CNL-16-105

Browns Ferry Nuclear Plant, Units 1, 2, and 3
Renewed Facility Operating License Nos. DPR-33, DPR-52, and DPR-68
NRC Docket Nos. 50-259, 50-260, and 50-296

Subject: **Proposed Technical Specifications (TS) Change TS-505 - Request for License Amendments - Extended Power Uprate (EPU) - Supplement 22, Responses to Requests for Additional Information**

Responses to NRC Requests for Additional Information

Figure SCVB-RAI 2-1
Comparison of EPU Short-Term Recirculation Suction Line Break DBA-LOCA Containment
Pressure Responses
(Design Condition: Initial DW Temperature =70°F)
The case identified by the solid curve is the same case in Reference 1, Figure 2.6-7.

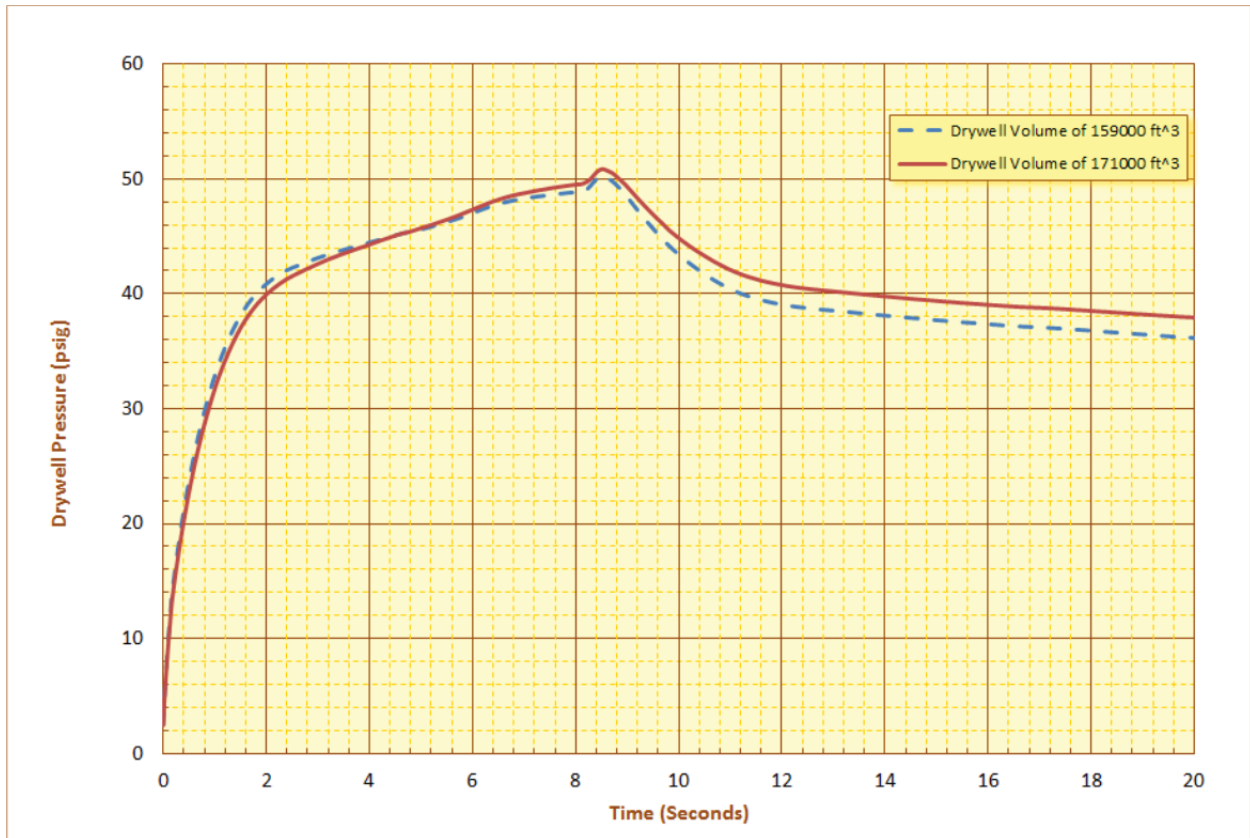
The above statement provides a qualitative justification for a higher drywell pressure response for a larger drywell volume. For the short term drywell pressure response, it would seem that using the larger drywell volume of 171,000 ft³ would result in a less limiting pressure response than using the minimum volume of 159,000 ft³. Confirm that maximum drywell and wetwell pressure response mentioned above (using the larger drywell volume of 171,000 ft³) was obtained by a sensitivity analysis performed using the LAMB and M3CPT computer codes for drywell volumes of 171,000 ft³ and 159,000 ft³ using same assumptions and same remaining input parameters.

In response to this RAI, a sensitivity run was made for the design case in Table 2.6-1 of Reference 1 (PUSAR) by changing only the initial drywell volume from 171,000 ft³ to 159,000 ft³. The comparison of drywell pressures for those two cases is shown in Figure SCVB-RAI 2-1, which is consistent with the discussion given above. For the case at design conditions in Table 2.6-1, the initial drywell volume is 171,000 ft³ and the peak DW pressure is 50.9 psig. The peak DW pressure is 50.3 psig with a smaller drywell initial volume of 159,000 ft³.

Figure SCVB-RAI 16-1: CLTP/EPU LOCA DW TEMP Starting at 150°F

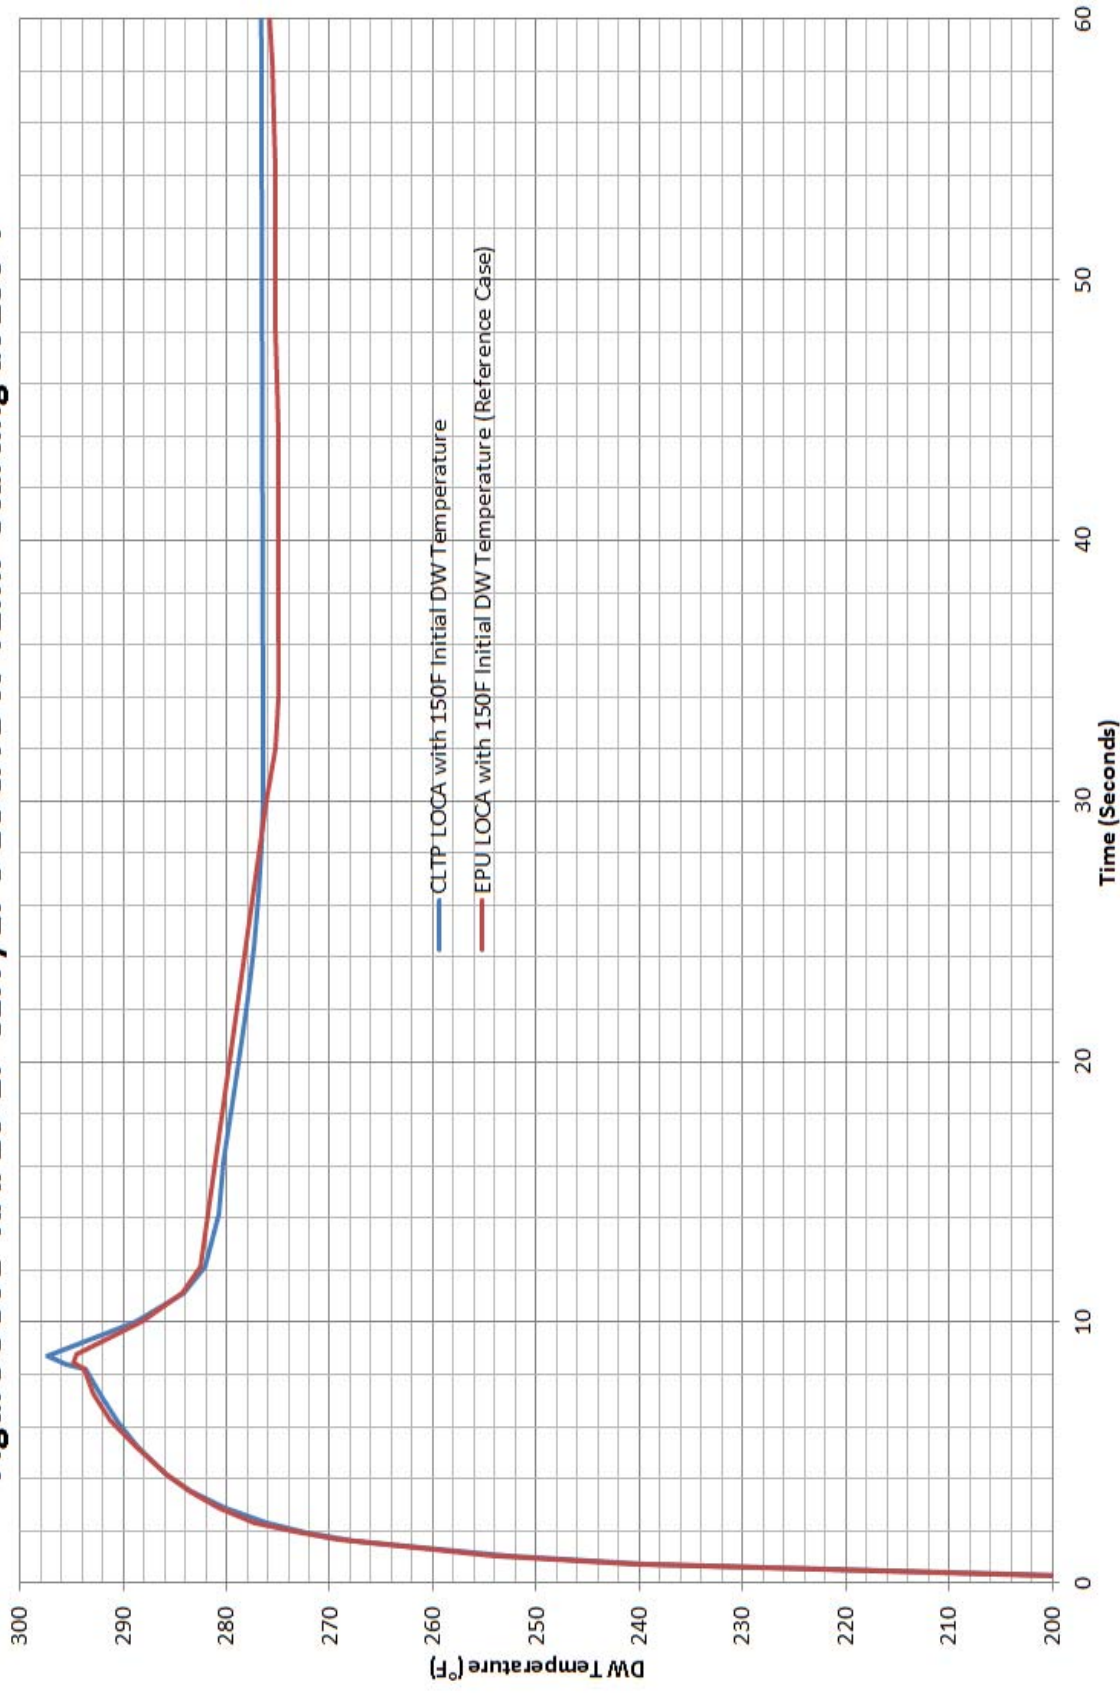
In the current response to GL 96-06, what are the drywell gas and the RBCCW temperatures used in the analysis to determine the boiling time of 61 seconds in the drywell cooling coils? State the basis for these temperatures and confirm that the both are limiting for the boiling time of 61 seconds in the RBCCW piping and the drywell cooler cooling coils. Provide the same temperature under the EPU conditions with justification that these are most limiting for the boiling time determination in the drywell cooling coils.

3) Figure SCVB-RAI 16-1 shows the drywell temperature profiles for a DBA-LOCA with an initial drywell temperature of 150°F for both CLTP and EPU conditions. In comparing the drywell temperature profiles, the discussion is separated into the following three time periods:

Based on the minor differences in the drywell temperature profiles and the margin between the RBCCW pump start (40 seconds) and calculated time to boil (61 seconds), it is concluded that voiding would not occur under EPU conditions prior to the restart of the RBCCW pump.

Figure SCVB-RAI 17-1
Clean Demineralizer System
(Typical of Units 2 and 3)

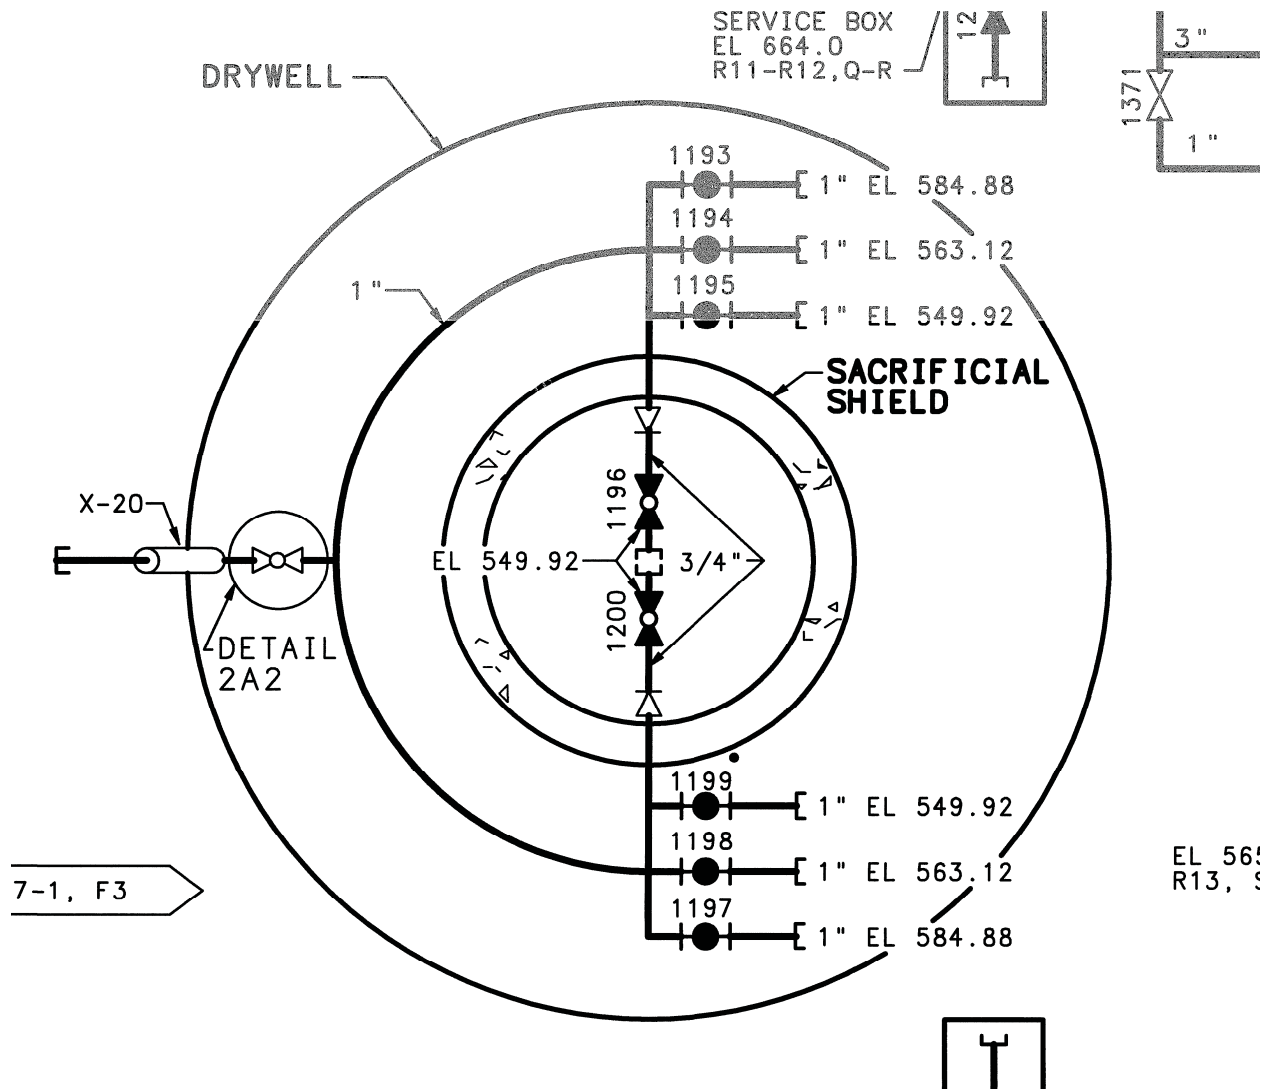
Section 2.6.1.5 of PUSAR provides the current and proposed responses to GL 96-06 for the demineralized water system, drywell floor drain sump discharge, drywell equipment drain sump discharge, and reactor water sampling system. For these systems, provide the penetration numbers in the UFSAR Table 5.2-2 for the piping between which containment isolation valves are under consideration for GL 96-06.

- 1) The penetration for the Demineralized Water System is X-20 on all three units. (See Figure SCVB-RAI 17-1.)
 - a) Unit 1 - The demineralized water penetration was cut and capped by a modification and some of the piping inside the drywell has been removed. The possibility for pressurization due to heat-up of trapped water in the piping no longer exists for this line on Unit 1.
